**SUNDRY NOTICES AND REPORTS ON WELLS**  
*Do not use this form for proposals to drill or to re-enter an abandoned well. Use form 3160-3 (APD) for such proposals.*

8. Well Name and No.  
PEACHES 19 FEDERAL 4H

OXY USA Inc. respectfully requests approval for the following changes to the drilling plan:

**PECOS DISTRICT  
CONDITIONS OF APPROVAL**

**Plan: Plan #1**

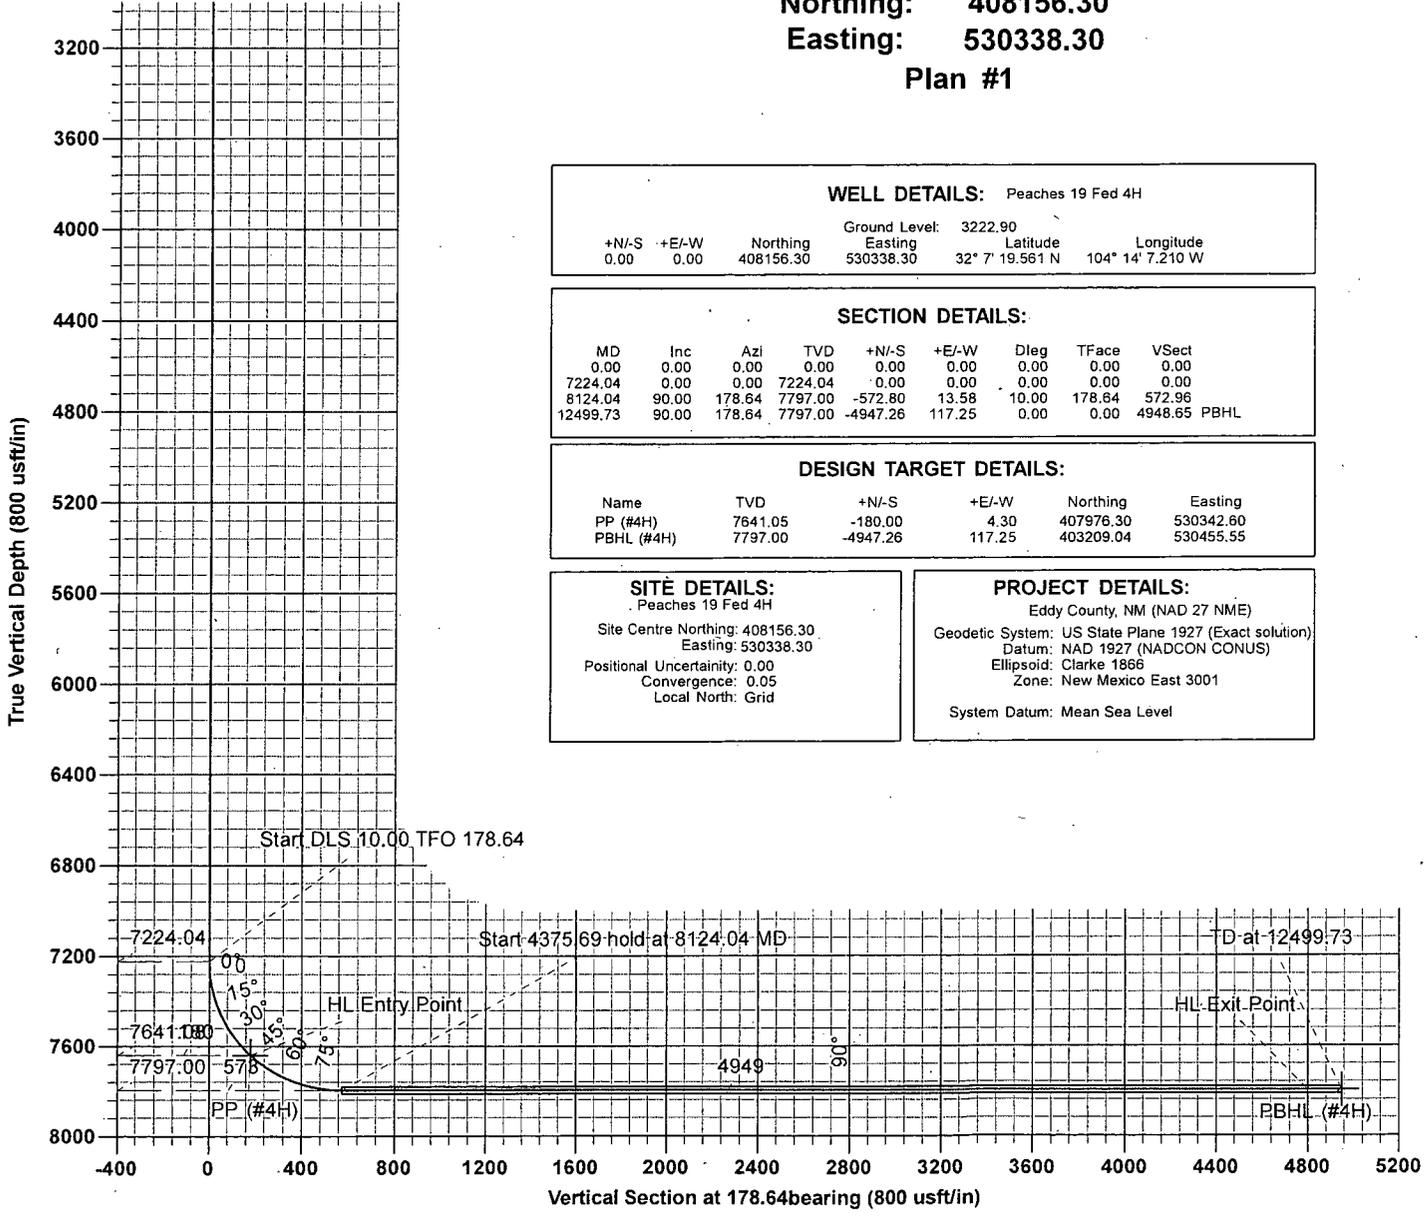
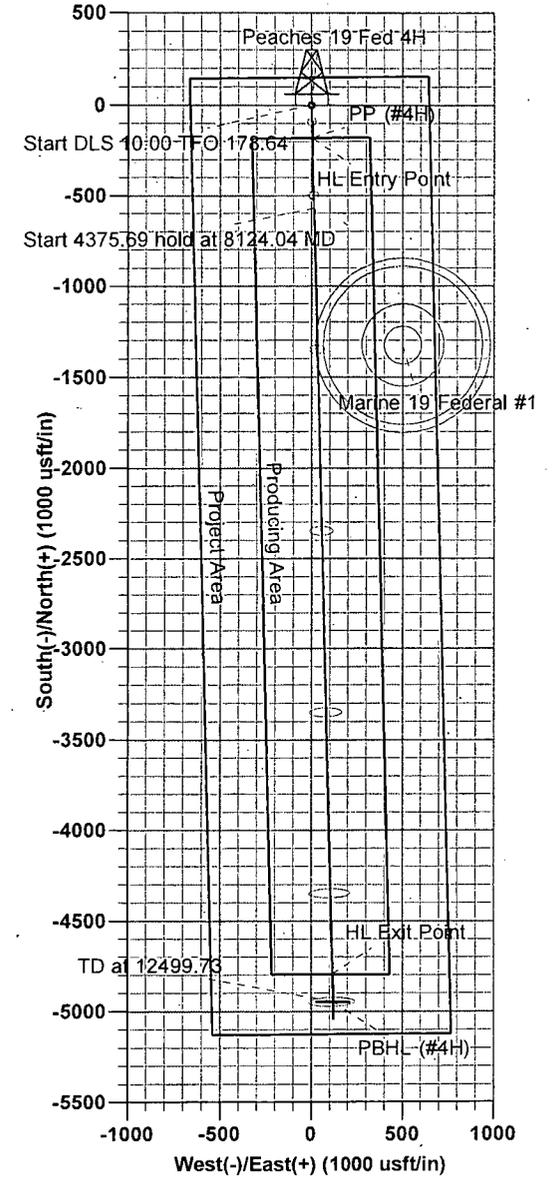
Proposed TD - 12500'M 7797'V

# 5M Choke Panel

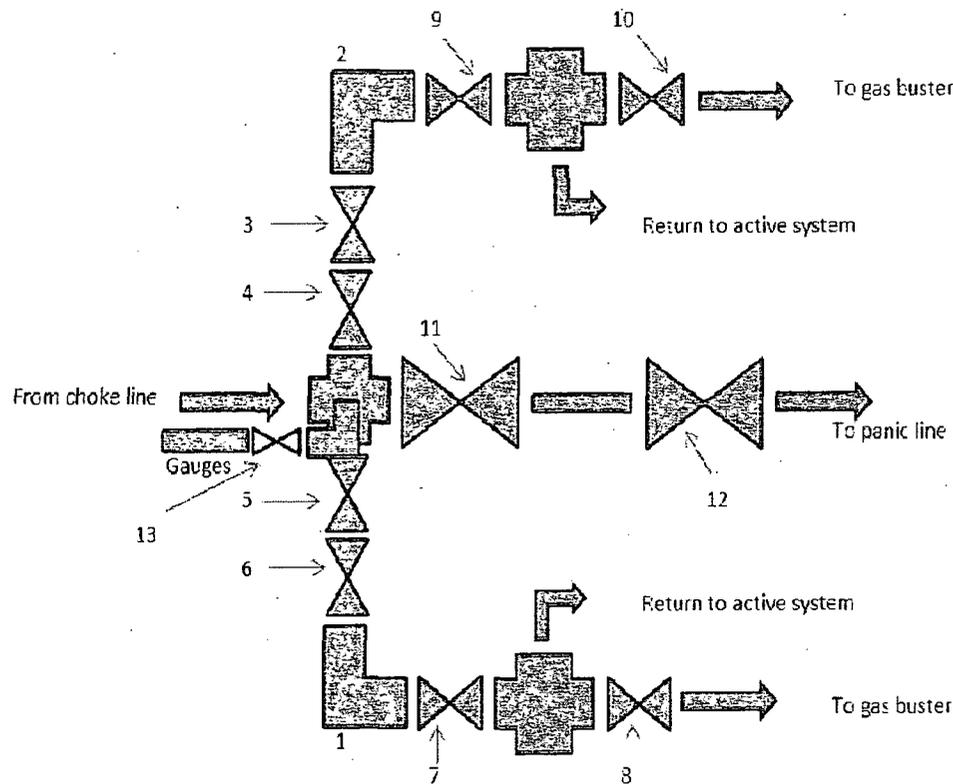
4. The Operator will connect the BOP choke outlet to the choke manifold using a hose that meets all BLM requirements and will be inspected and approved by BLM personnel prior to spud.

2. Variance approved to use flex line from BOP to choke manifold. Check condition of flexible line from BOP to choke manifold, replace if exterior is damaged or if line fails test. Line to be as straight as possible with no hard bends and is to be anchored according to Manufacturer's requirements. The flexible hose can be exchanged with a hose of equal size and equal or greater pressure rating. **Anchor requirements, specification sheet and hydrostatic pressure test certification matching the hose in service, to be onsite for review. These documents shall be posted in the company man's trailer and on the rig floor.** If the BLM inspector questions the straightness of the hose, a BLM engineer will be contacted and will review in the field or via picture supplied by inspector to determine if changes are required (operator shall expect delays if this occurs).
